Subject: Supports of projecting
sign for Douglas Shoe Co. on
building at 513 Congress St.
owned by the Est. of Harriott
L. Morris

Memorandum from Department of Building Inspection, Portland, Maine
533 Congress St.* Projecting Sign for Douglas Shoe Co. by United Neon Display.
9/20/41

Location 553 Congress Street

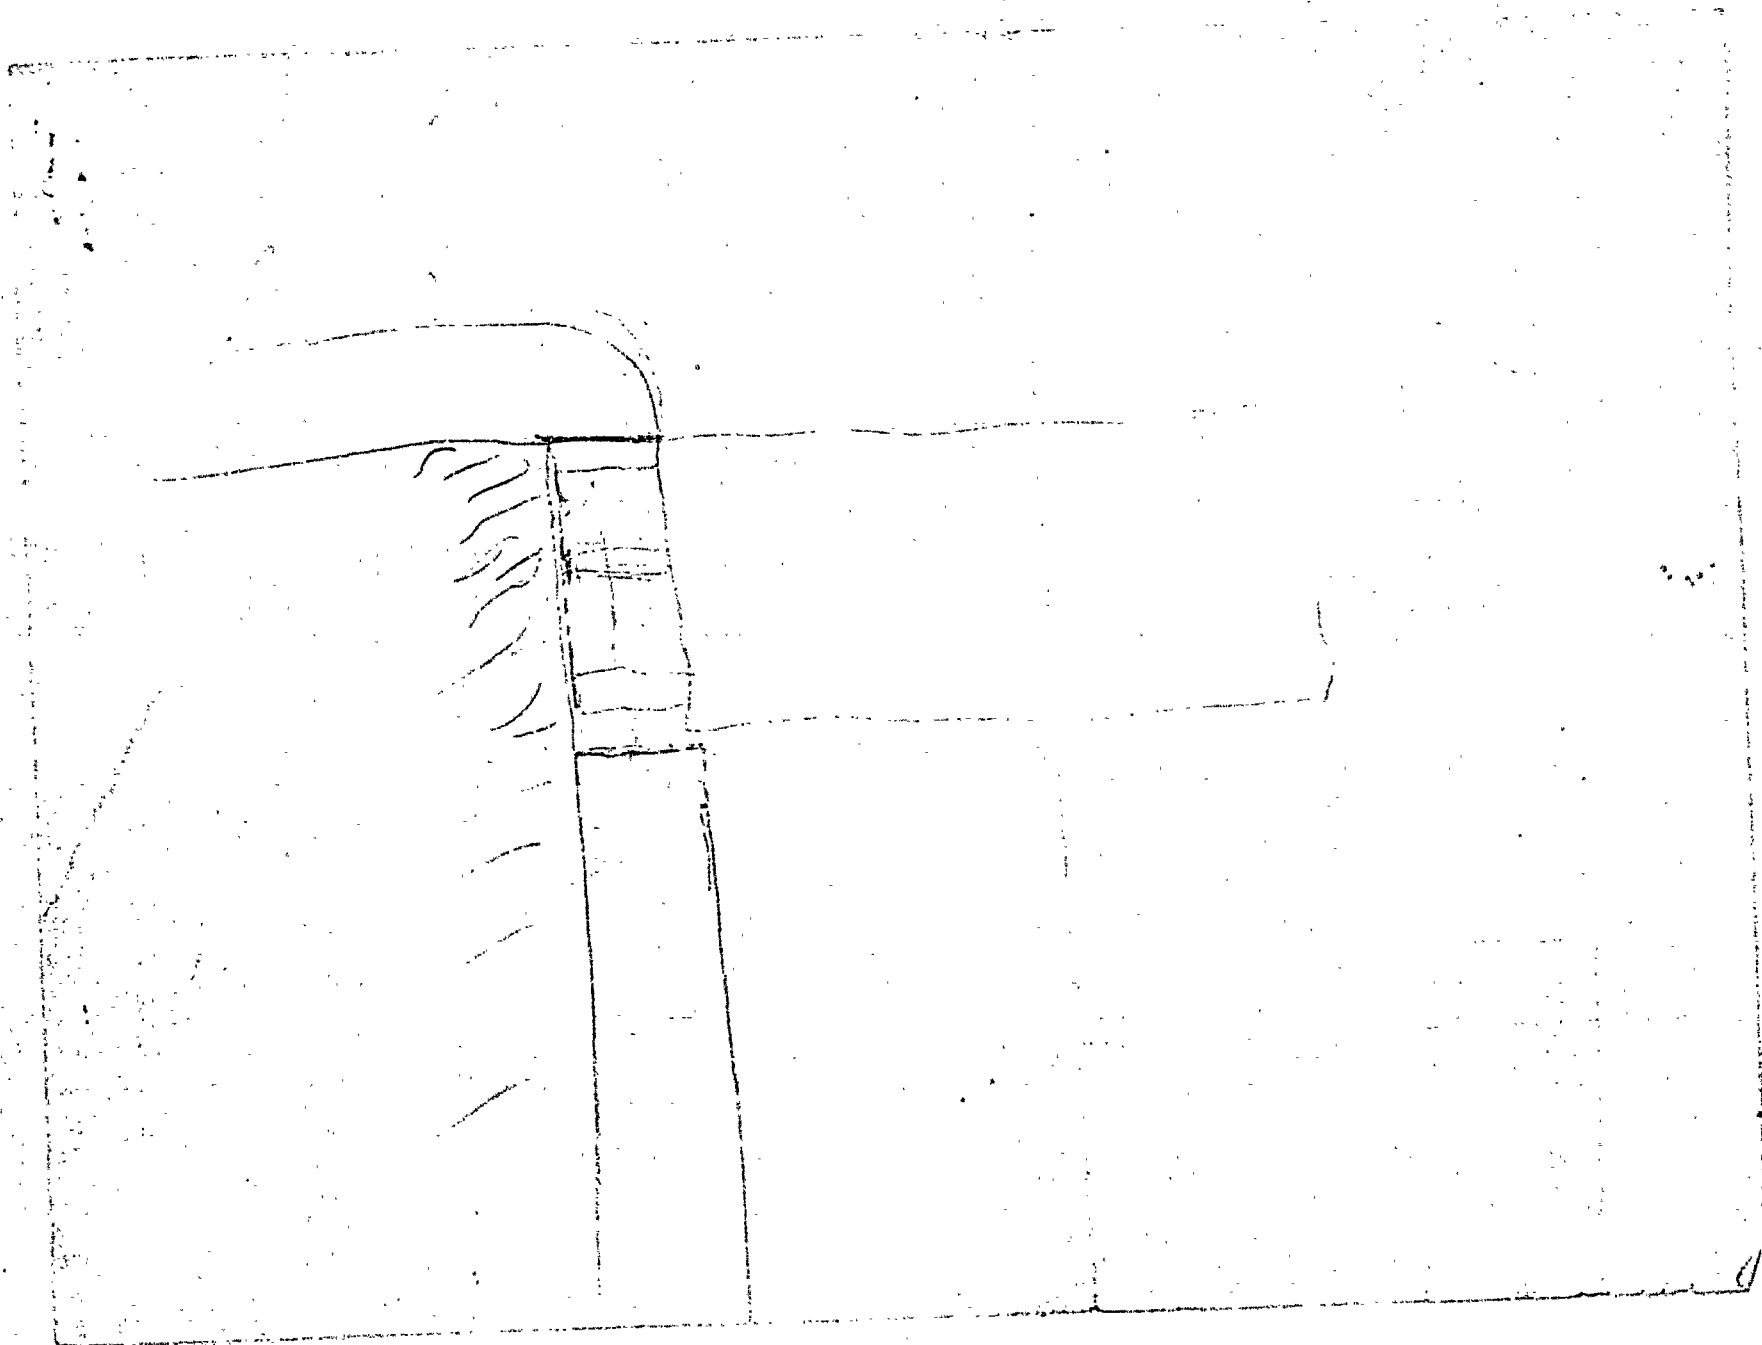
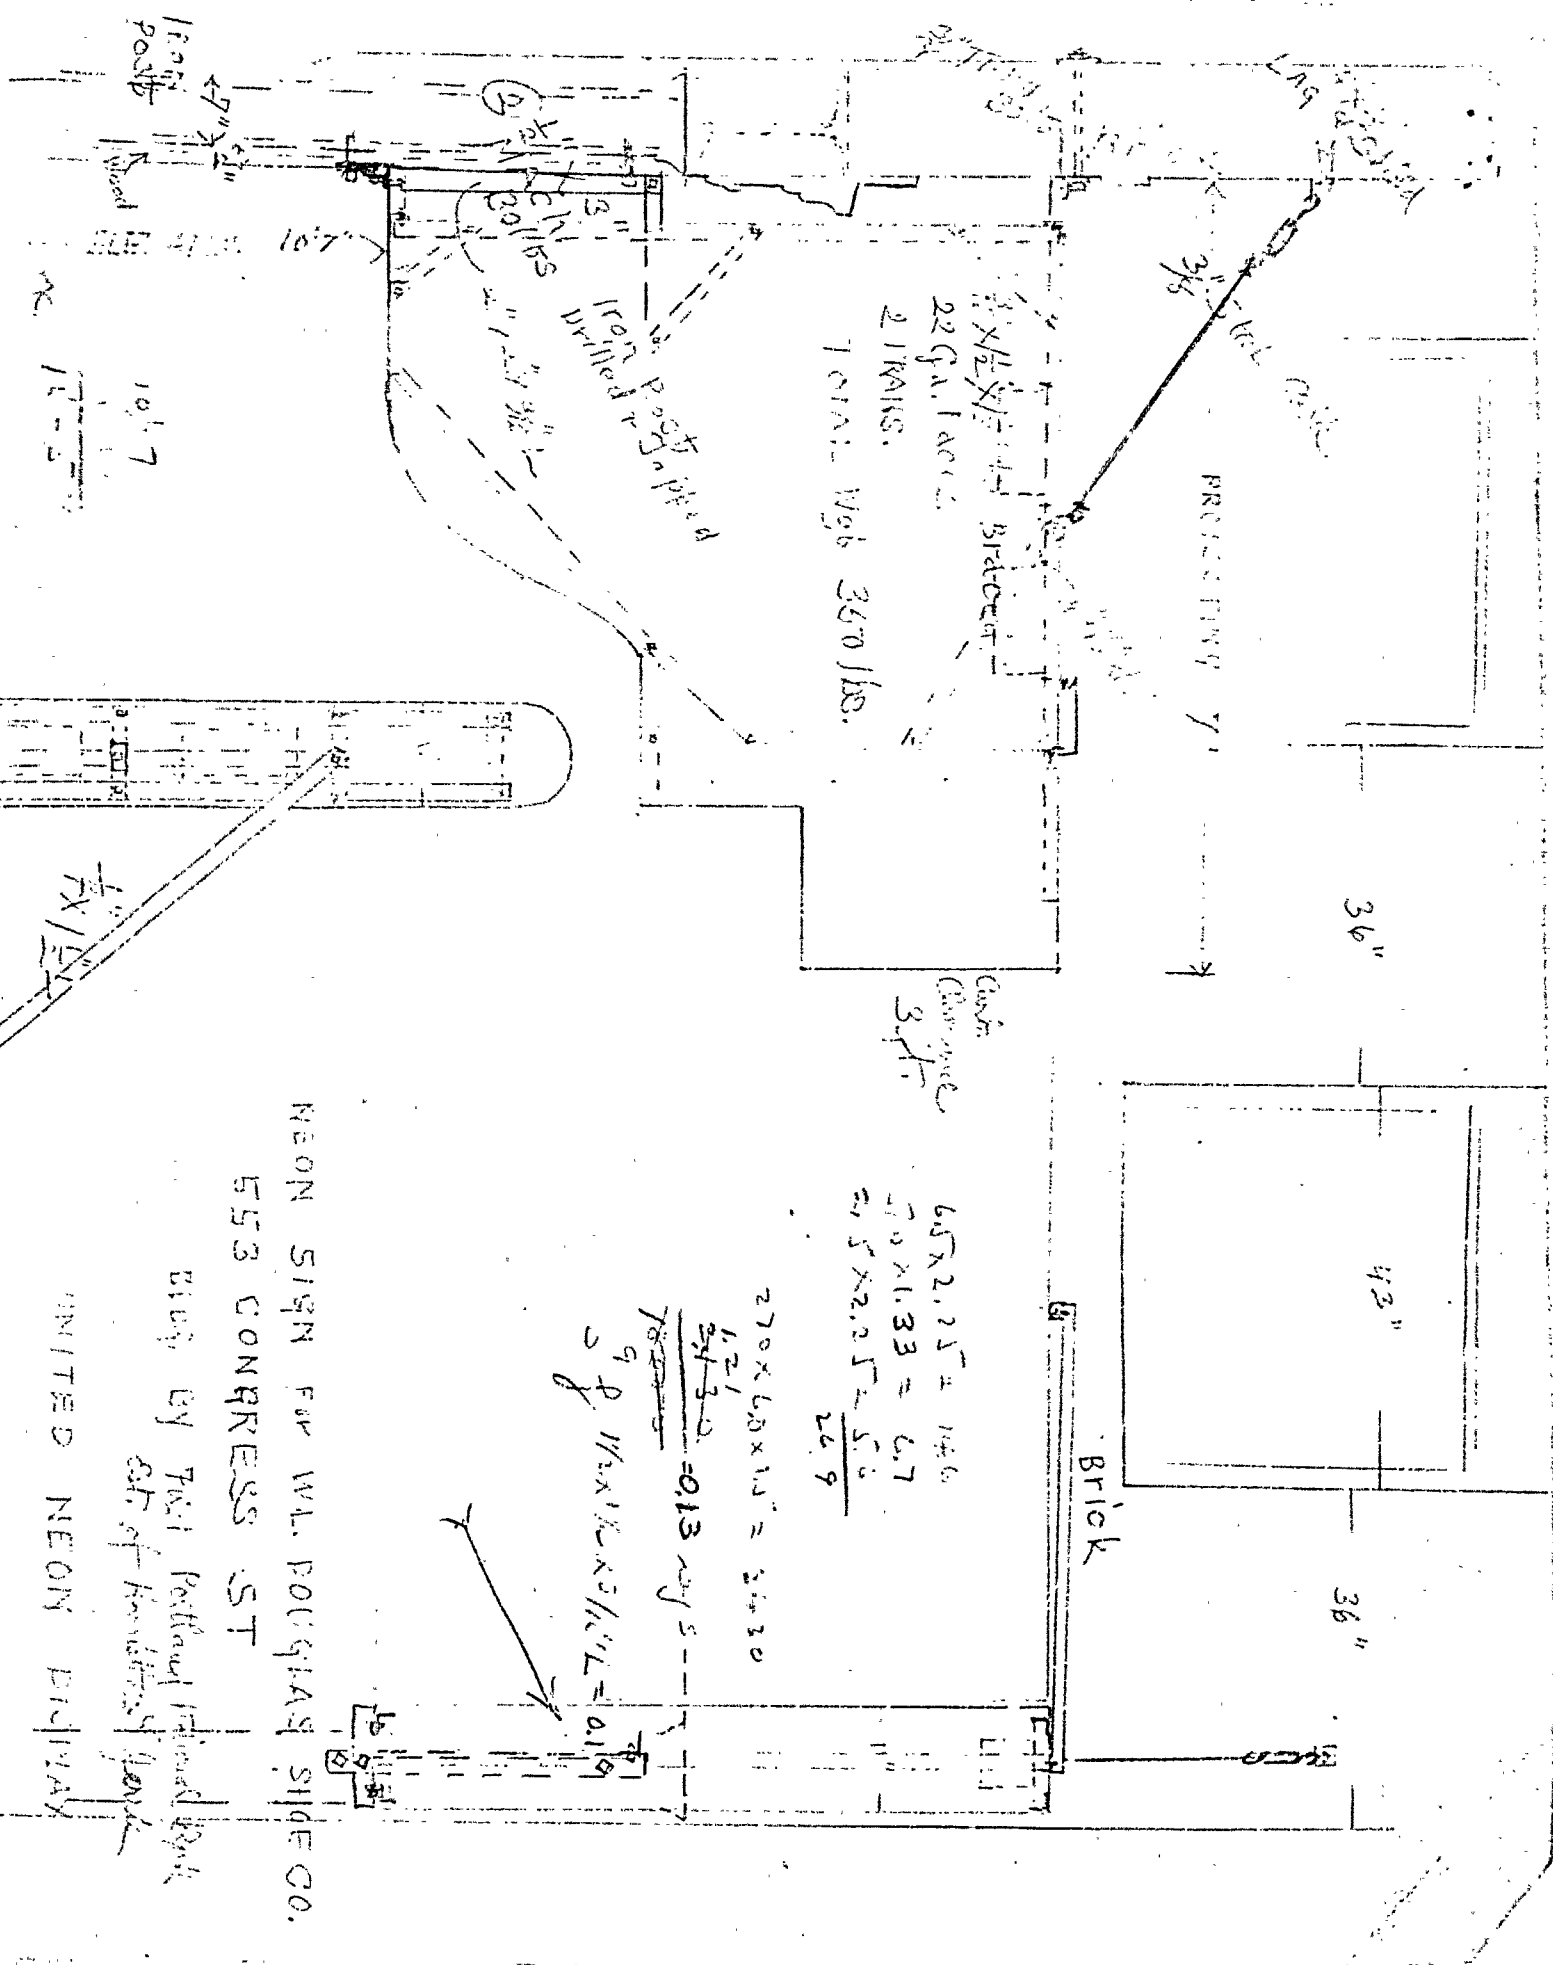
This sign does not appear stiff enough with only one side guy, and the lower horizontal angle fastened to the building would not be long enough to guy to. I suggest that the horizontal angle of frame between the lower short one and the top horizontal angle be extended to a suitable connection to the building, and either that a side guy be attached to it or the horizontal angle be made heavier so as to work out as a cantilever without a side guy or at least a short one or gusset plate.
